Shoulder Hub Modifications

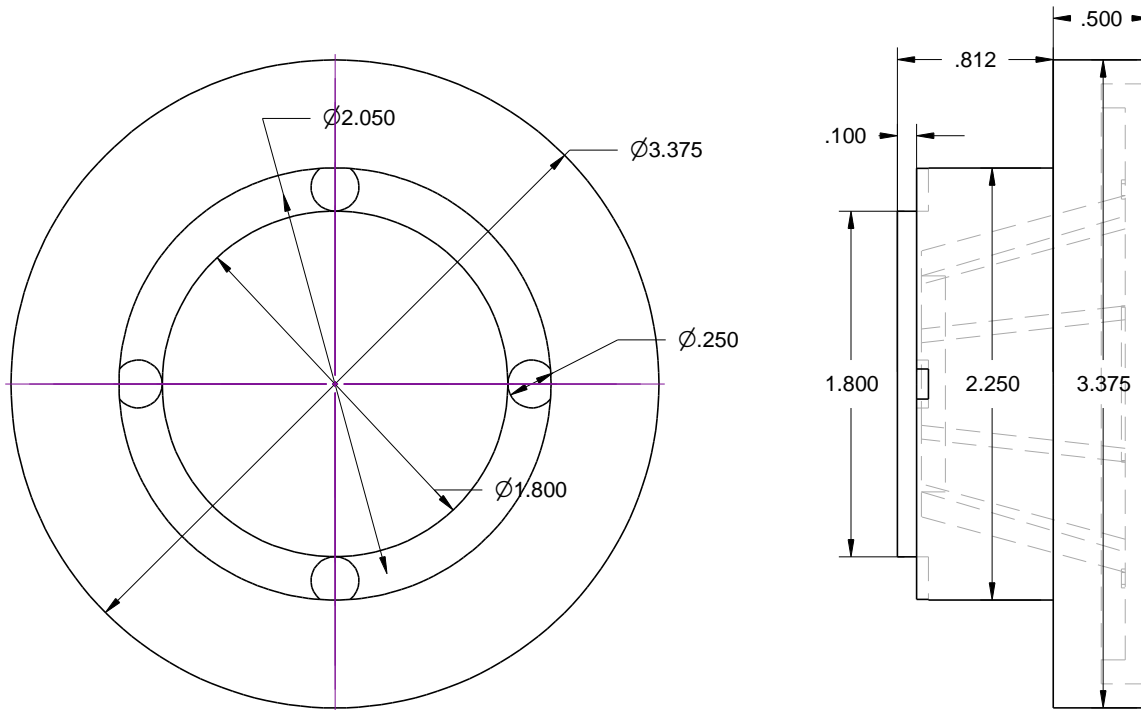
Remove .1 in. from the edge to reduce the diameter to 1.8 in

Make 4 holes spaced 90 degrees apart .25 in in diameter .0625 deep on a diameter of 2.05 in.

[note: outside edge of hole extends beyond edge of shoulder hub]

Use an end mill cutter, or equivalent, to cut a hole with a flat bottom.

Holes are designed to mount K&J Magnetics D41-N52 magnets 1/4 in x 1/16 in size.
